DESIGN REVIEW BOARD APRIL 20, 2018

ALPHARETTA CITY HALL
COUNCIL CHAMBERS
2 PARK PLAZA
8:30 AM

DESIGN REVIEW BOARD FEBRUARY 16, 2018

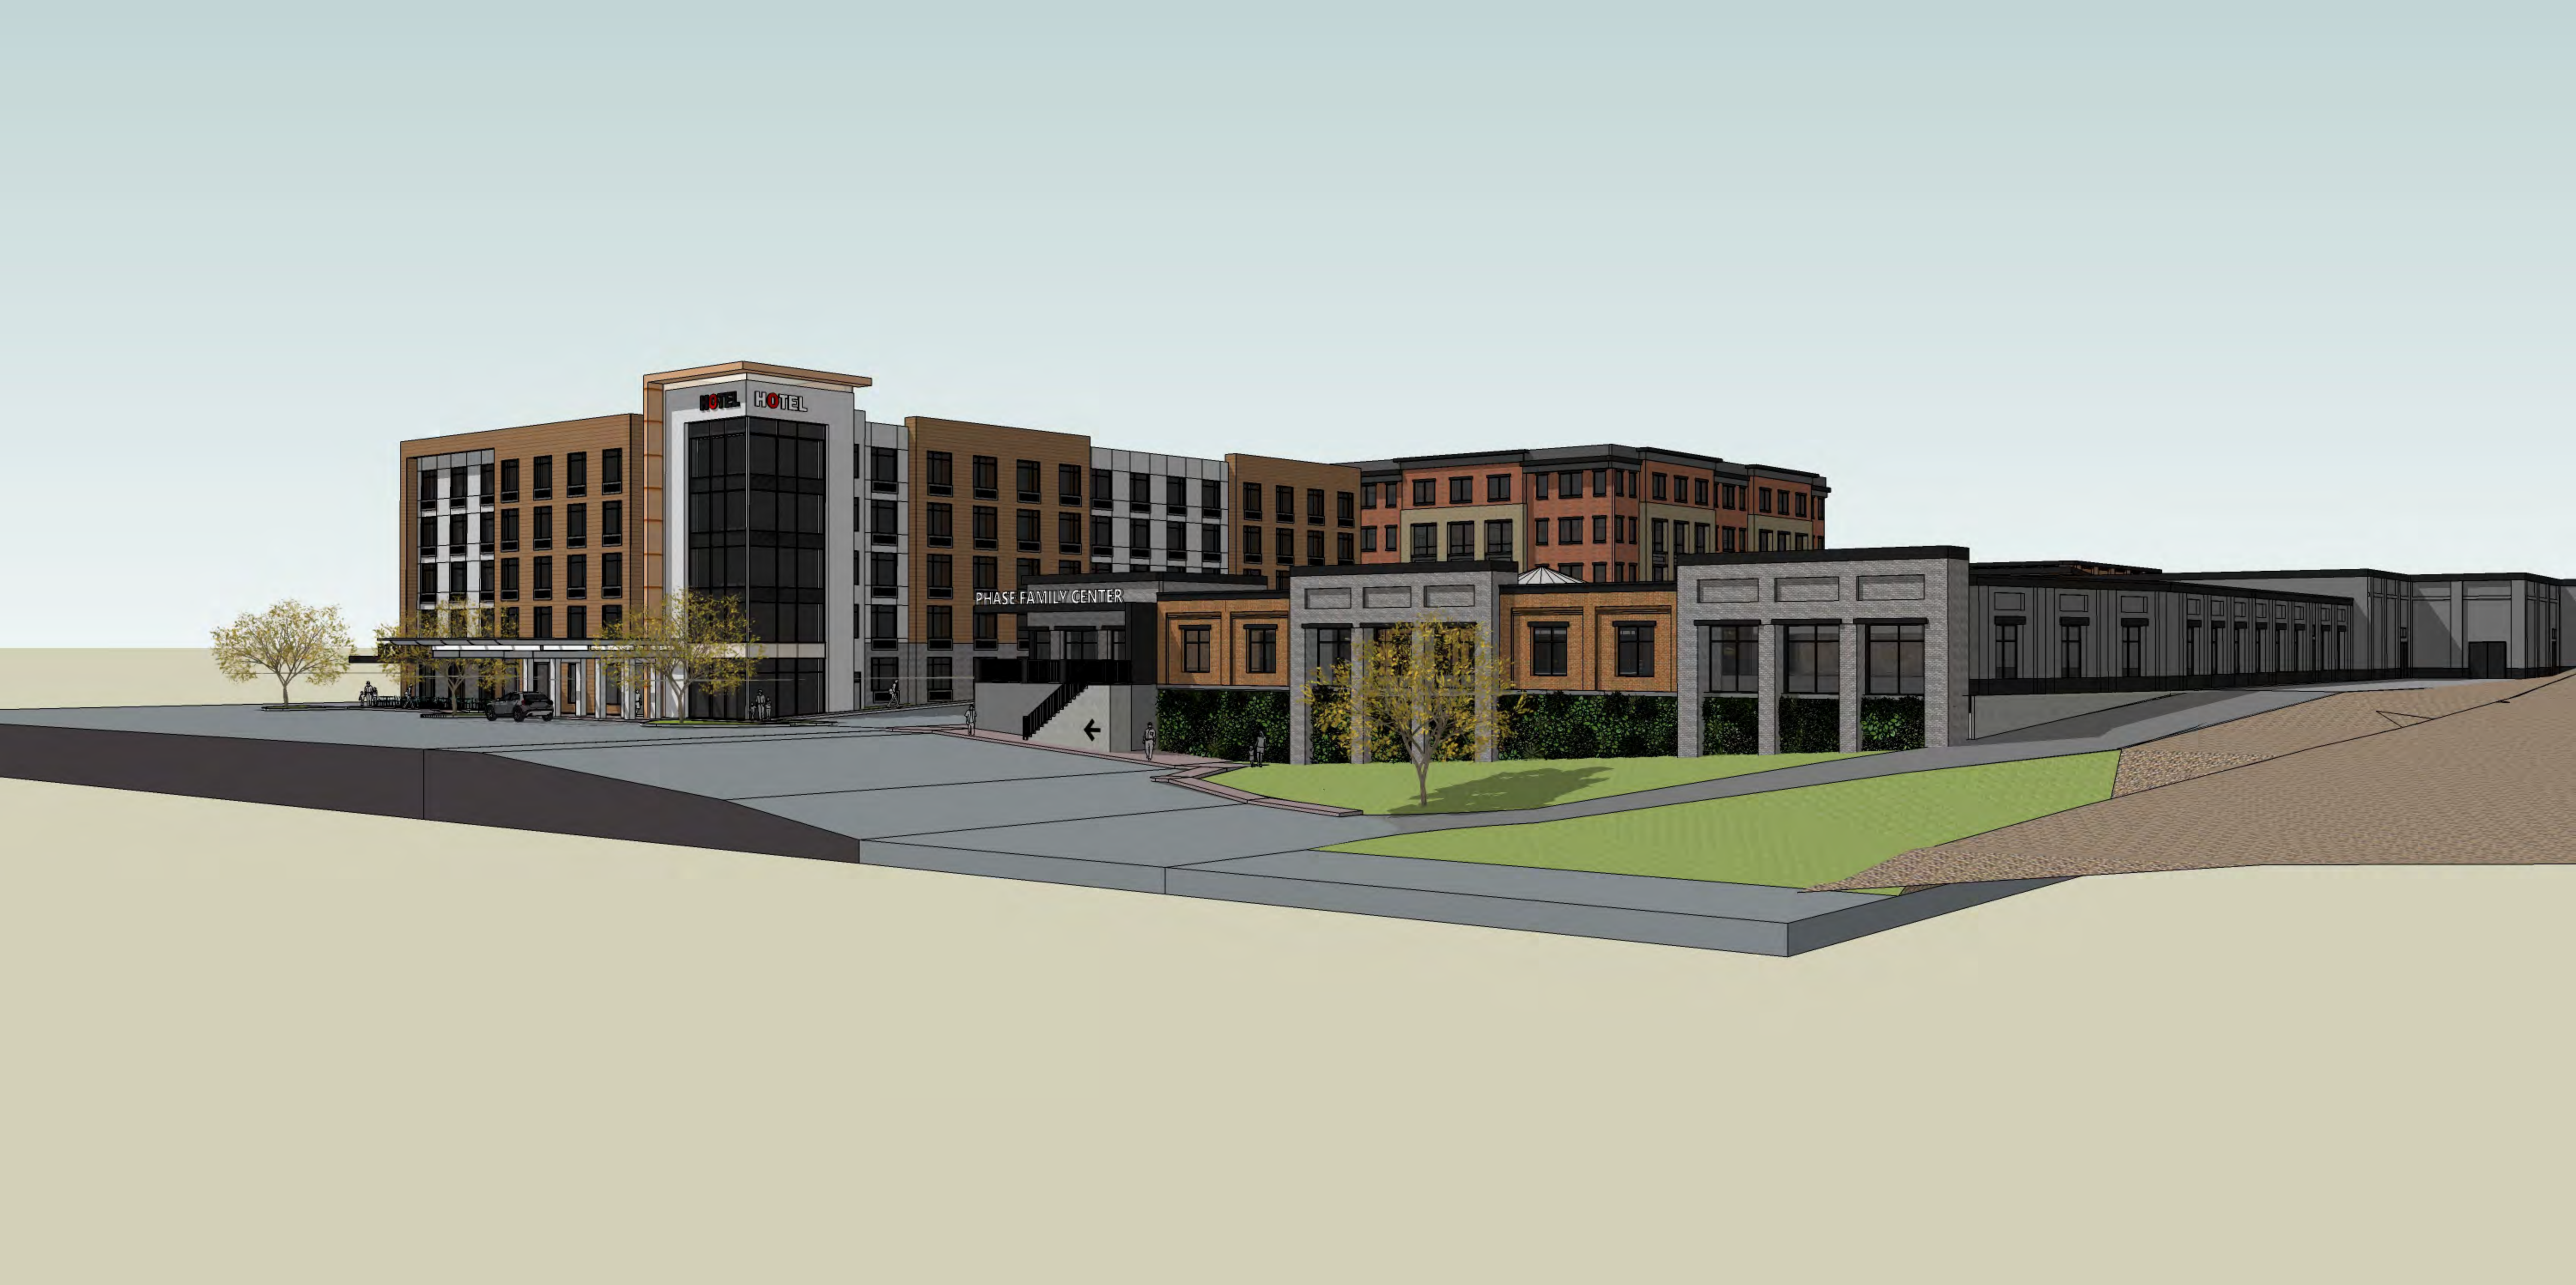
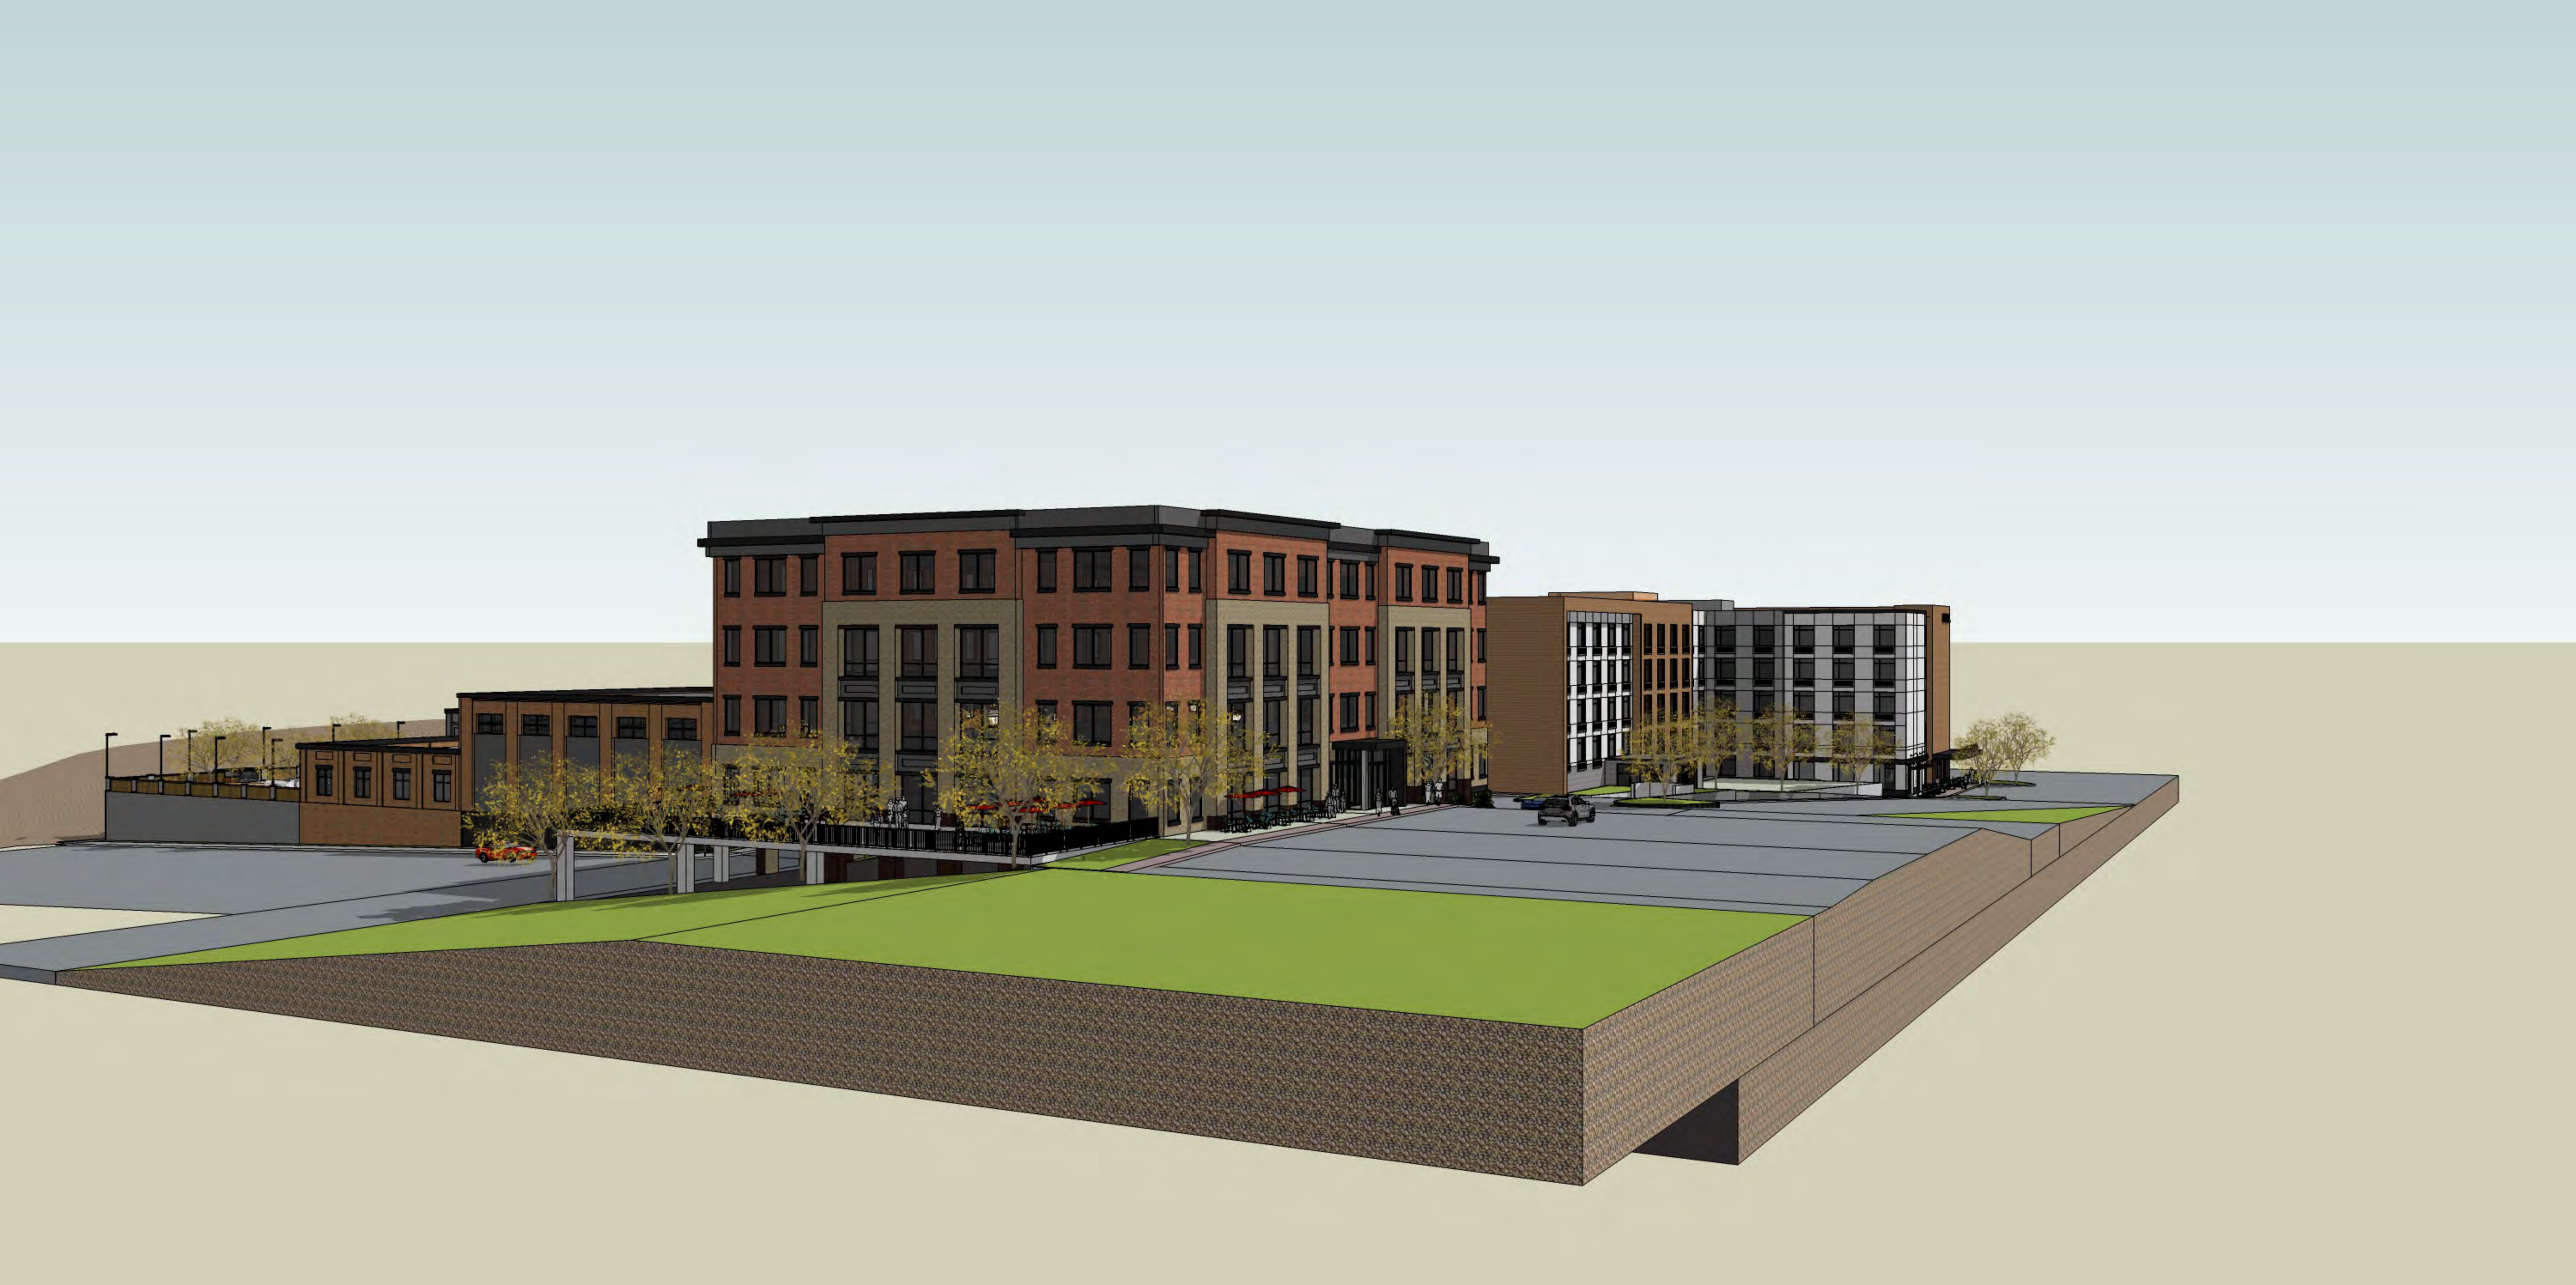
- Site Plan could change
- Landscape
- Detention Pond
- Walls not visible from Morris Rd.
- Property is part of Preston Ridge Master Plan
- Elevations
 - Provided samples
 - Blank gray wall
 - Possibly adding brick accents
 - Roof top units
 - Elevations with materials

1. Material changes in the Auditorium to make it blend with the rest of the building and break up the big mass of gray
2. More specifics on all the materials on the elevations – samples of the mortar
3. Final Site Plan

- ❖ Board Member Schwing offered a motion to defer for the Applicant to consider comments from today
- The motion received a second from Board Member Palmer
- The motion was approved by a vote (5-0)
